ULNRC- 04258

DOCKET NUMBER 50-483
UNION ELECTRIC COMPANY
CALLAWAY PLANT

REVISION TO TECHNICAL SPECIFICATIONS 3.3.2, 3.4.10, AND 3.4.11
PRESSURIZER SAFETY VALVES AND PORVS

Figure 7.6-4
Train B Functional Diagram Showing
Logic Requirements for Pressurizer
Pressure Relief System
Sheet 1

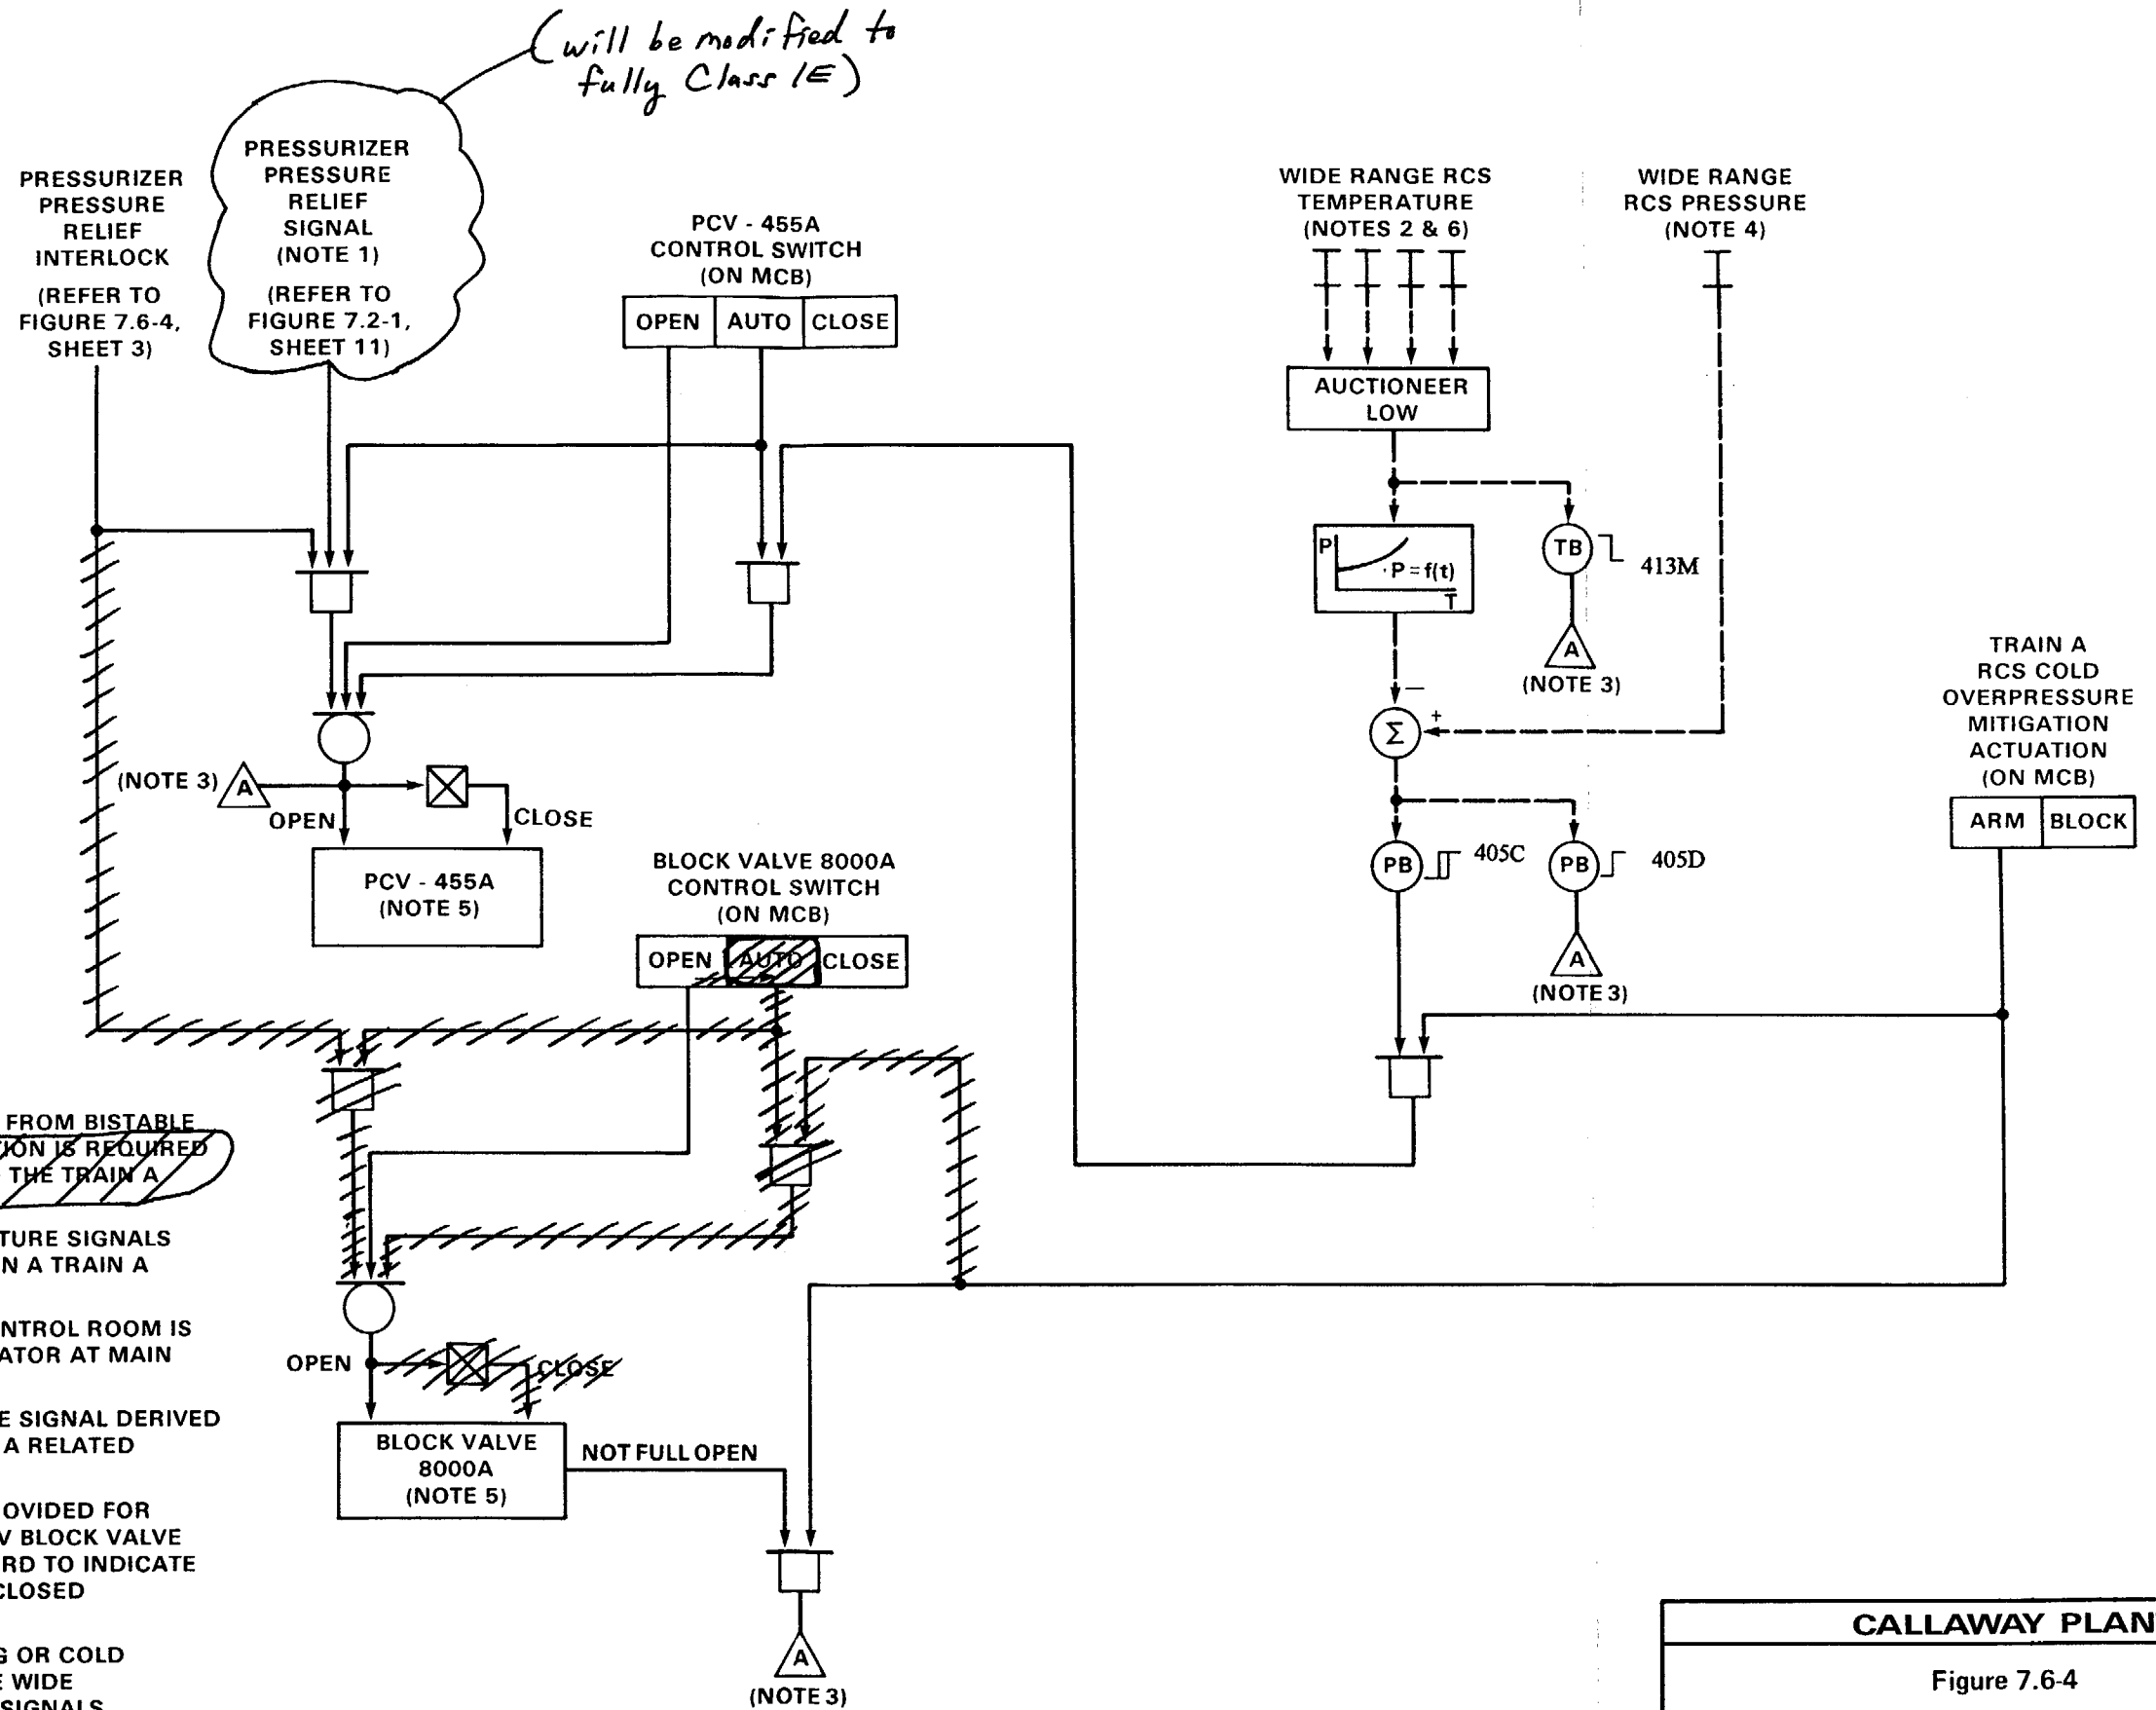
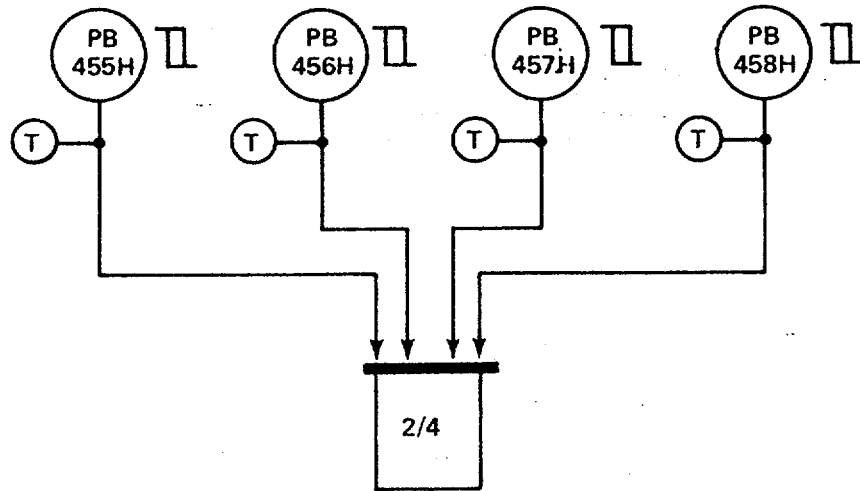
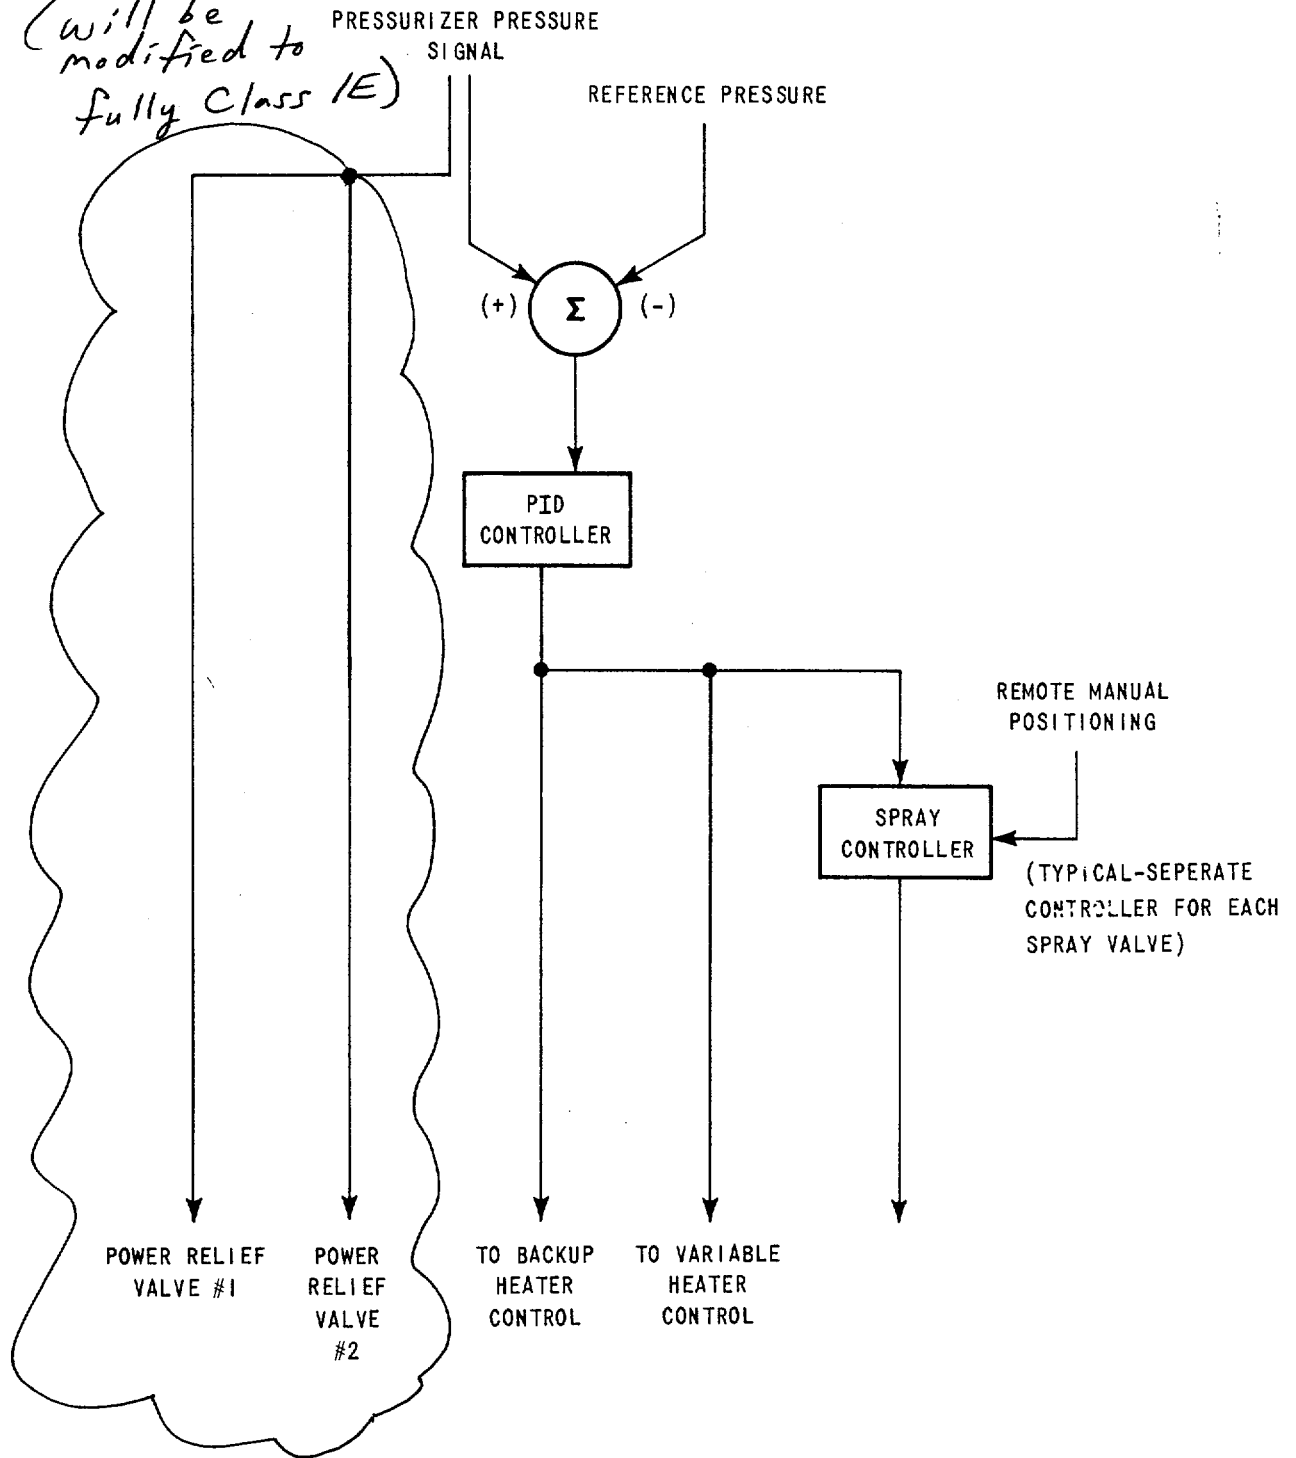
The current safety grade pressurizer PORV closure logic is also used to close the pressurizer PORV block valves (see FSAR Figure 7.6-4 sheets 1-3 in Attachment 6). From the main control room, the pressurizer PORV block valve handswitches can be in either in the OPEN, AUTO, or CLOSE position. When the handswitch is operated in AUTO, the current 2/4 closure logic automatically closes the pressurizer PORV block valves when pressurizer pressure drops below approximately 2200 psia. For the upgrade, the safety grade pressurizer PORV/ pressurizer PORV block valve closure logic will be used in the design of the safety grade pressurizer PORV opening logic. Since the pressurizer PORV block valves are not designed for continuous cycling, it is undesirable for these valves to automatically open and close with the pressurizer PORVs during an inadvertent ECCS actuation event. Therefore, the AUTO feature for the pressurizer PORV block valves will be eliminated. After the proposed modification is implemented, the pressurizer PORV block valves will be manually opened or closed from the main control room; there will be no automatic block valve actuation. The handswitches on the main control board will be changed from "OPEN-AUTO-CLOSE" to "OPEN-CLOSE".

FIGURE 7.7-4
BLOCK DIAGRAM OF PRESSURIZER
PRESSURE CONTROL SYSTEM

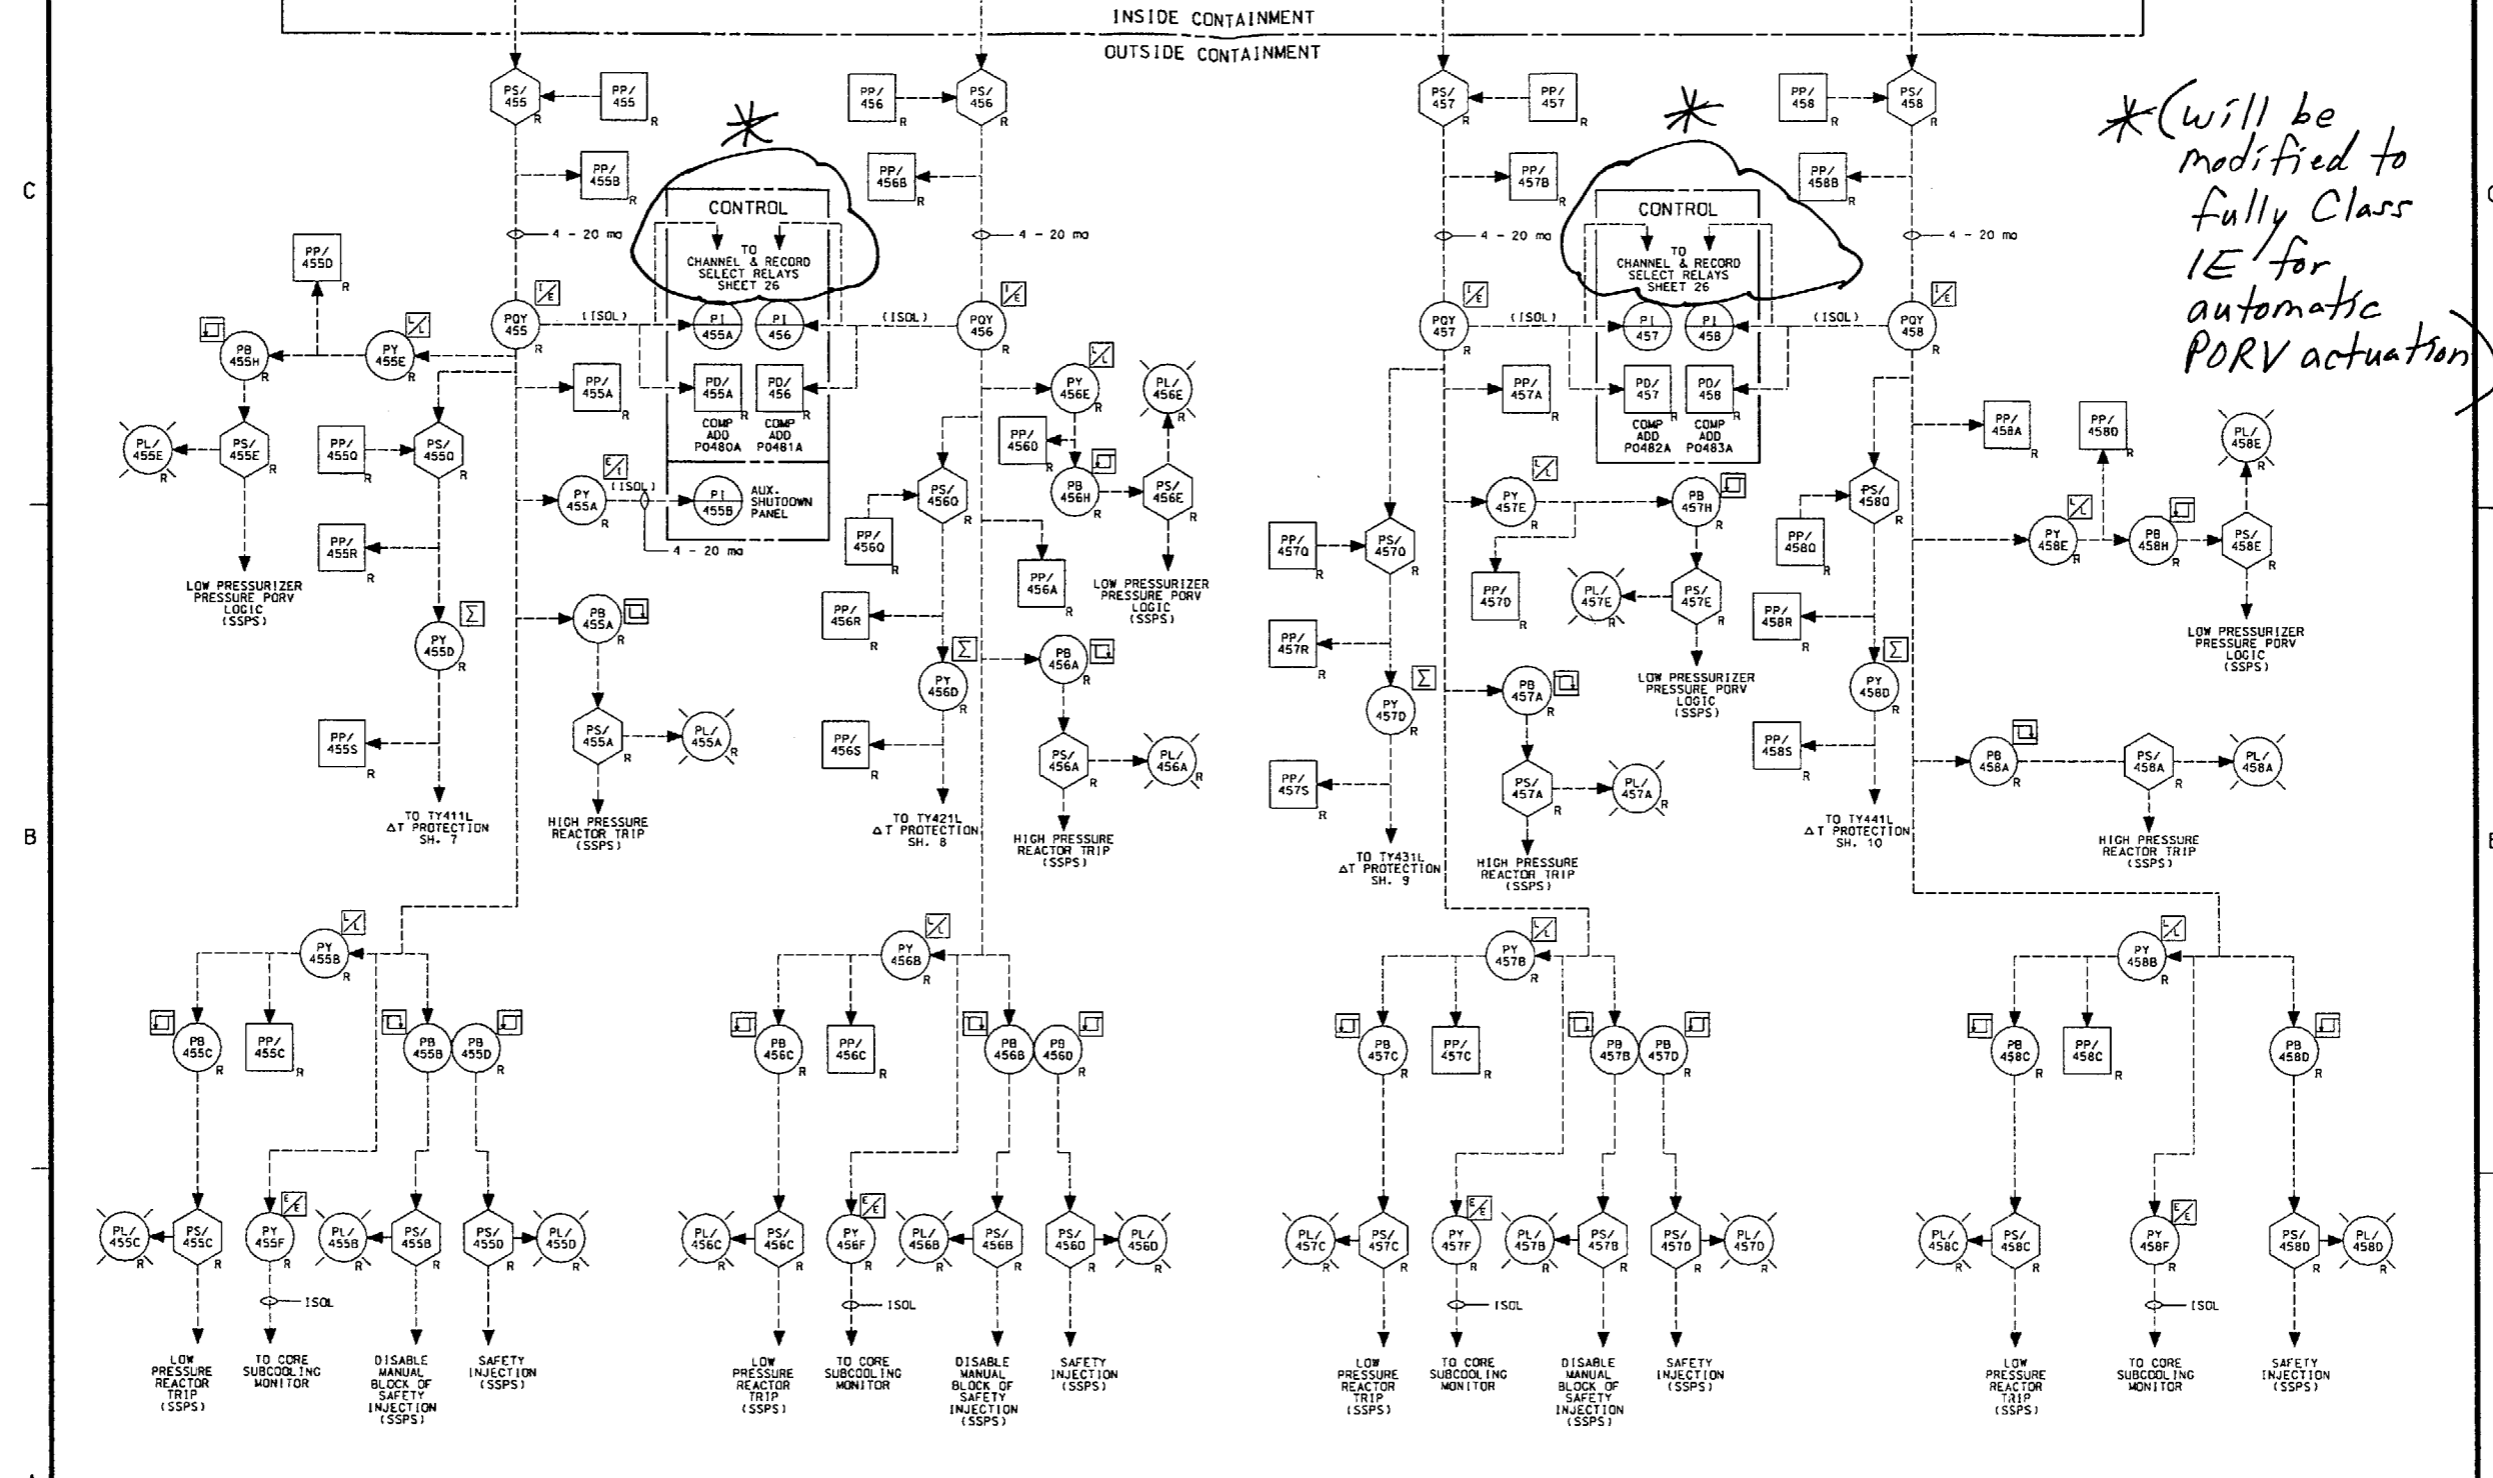
**(will be modified to fully Class 1E for automatic PORV actuation)*
